City of Pensacola

Agenda

2. 26-109 675 CENTROS STREET - GATEWAY REDEVELOPMENT DISTRICT-1 -
AESTHETIC AND SITE REVIEW

FORBES RESIDENCE
@ ARAGON (LOT D-4)
675 CENTROS STREET, PENSACOLA, FL 32502

Project No. 0724
Date: 11/24/25
Sheet No. A-201
BUILDING ELEVATION

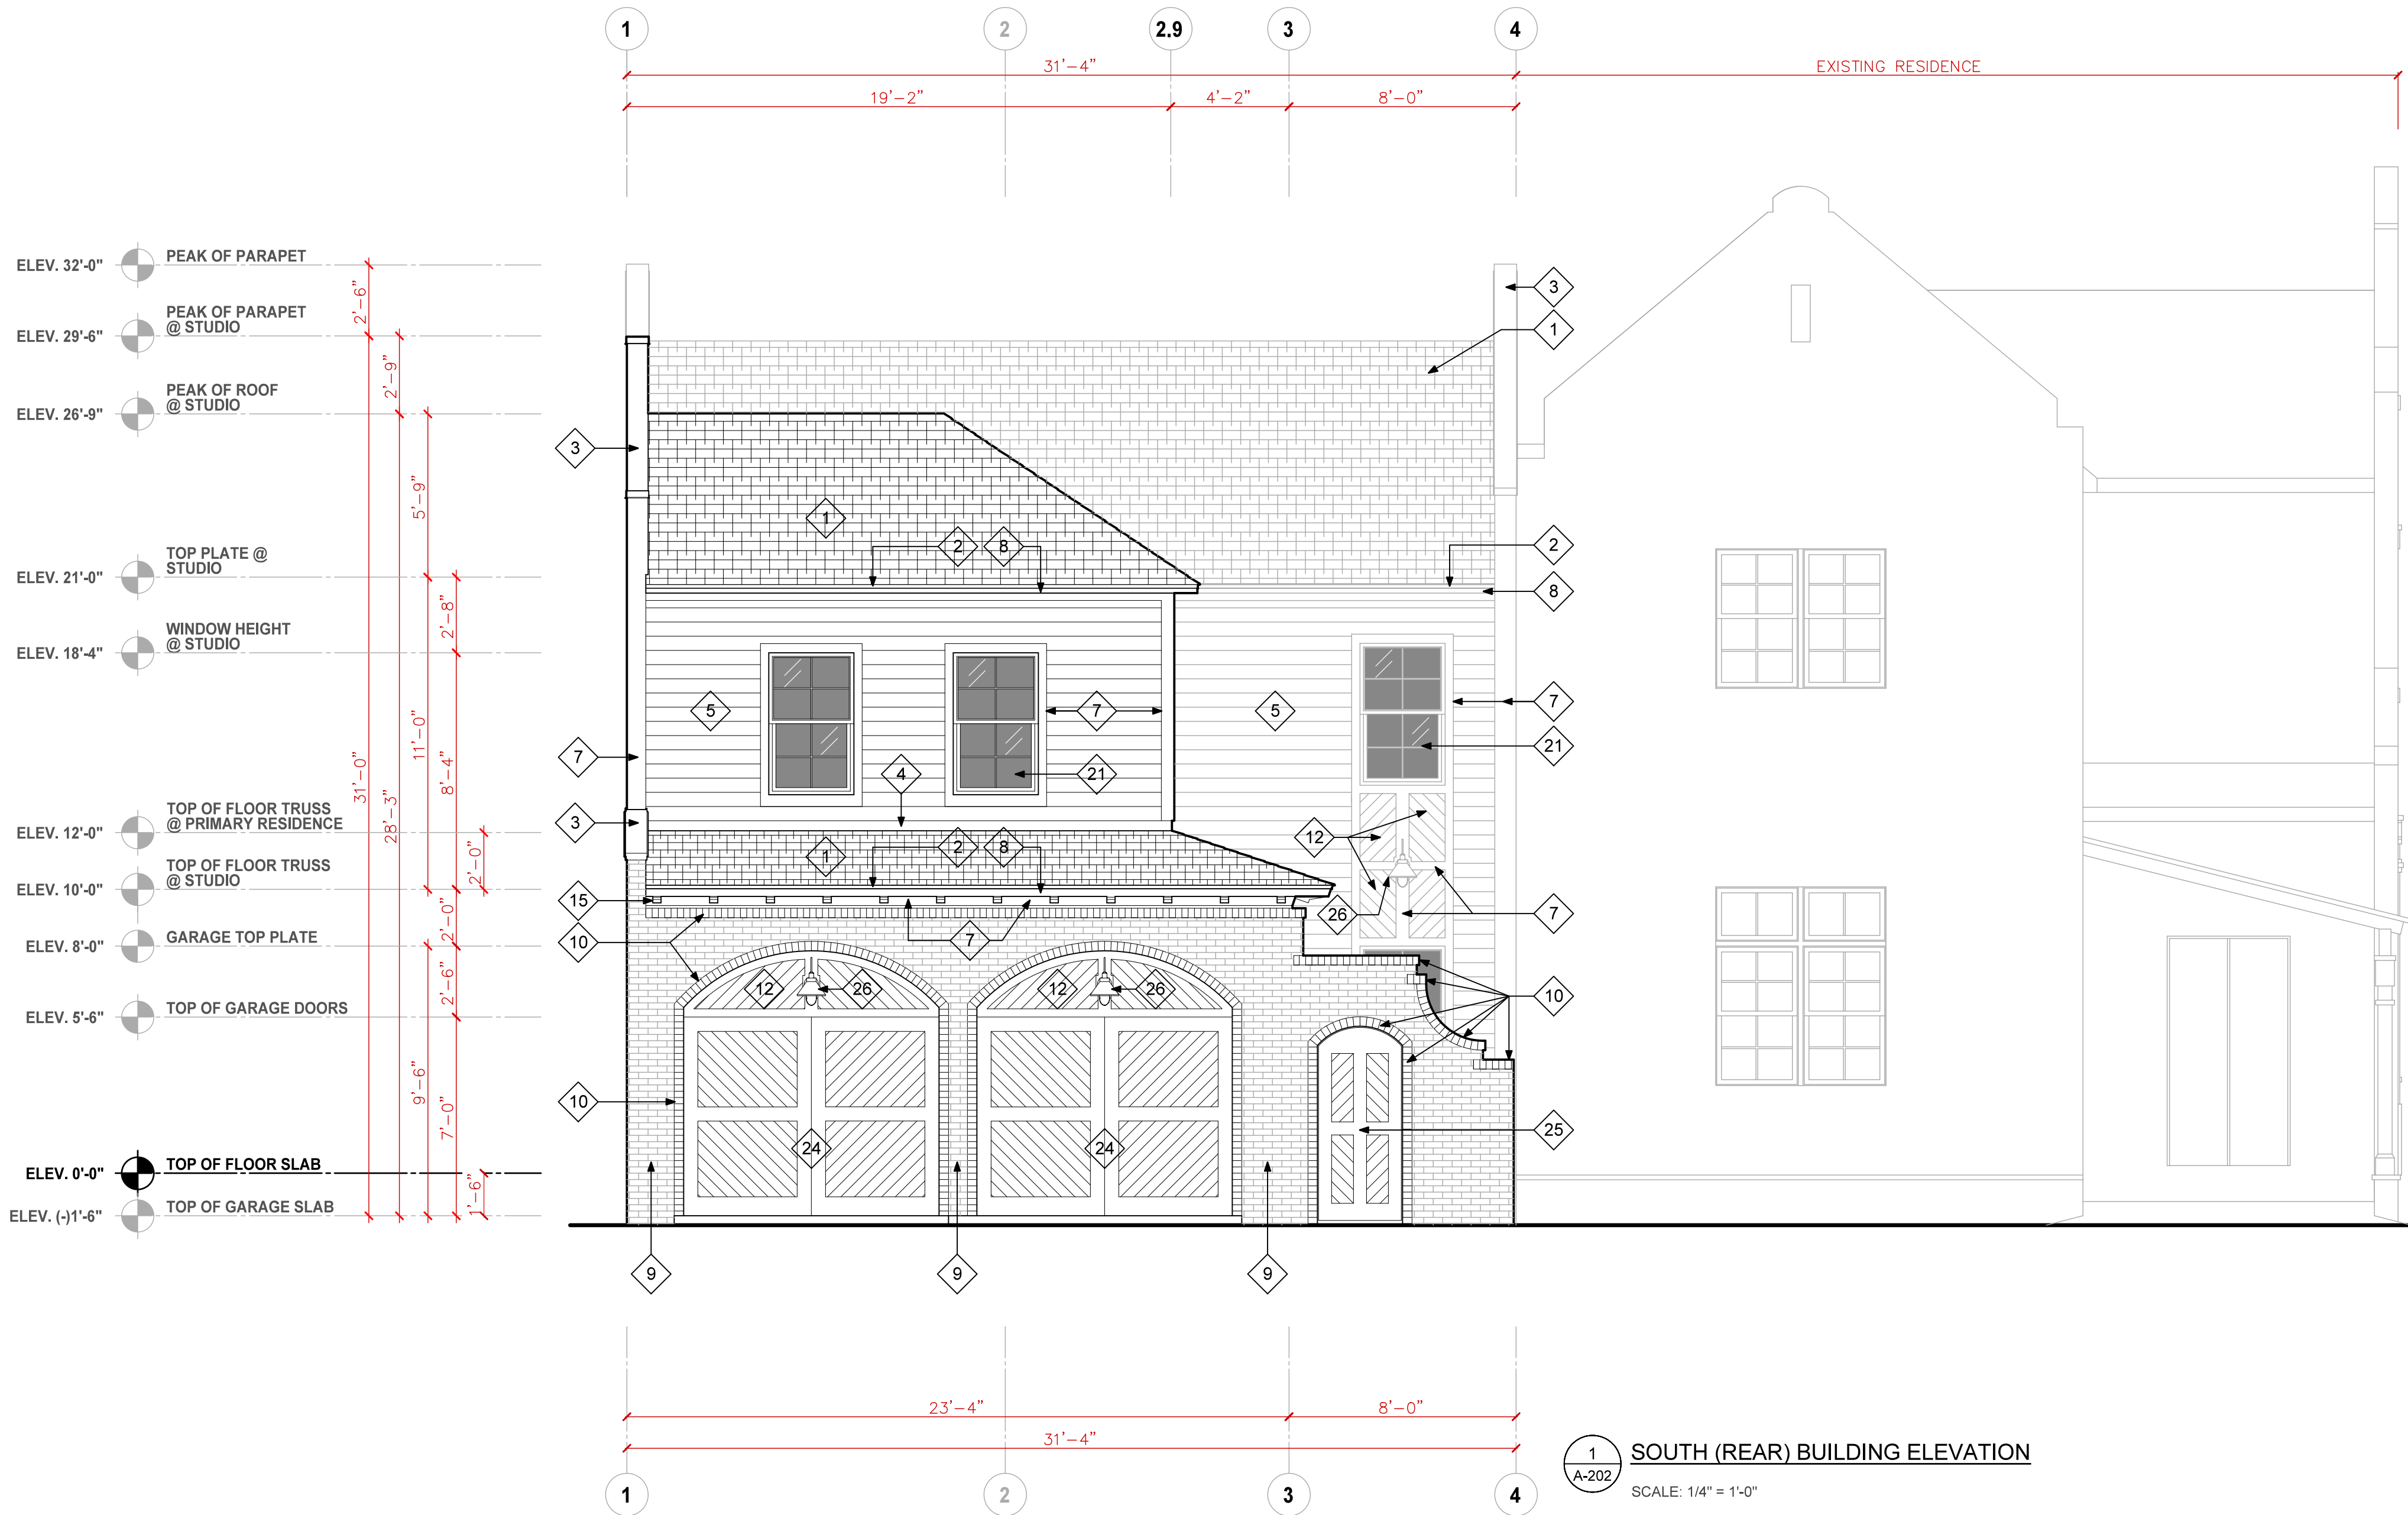
Mark - after further discussion, we have one remaining comment regarding the transom on the front elevation. If a 6'-8" tall door is preferred, the transom should be the same height as the adjacent ones - similar to the upper story.

Michael - See attached revised front elevation modifying the transom at the front door. Thanks for this suggestion. I agree that this improves the appearance. Please let me know if you need anything else.
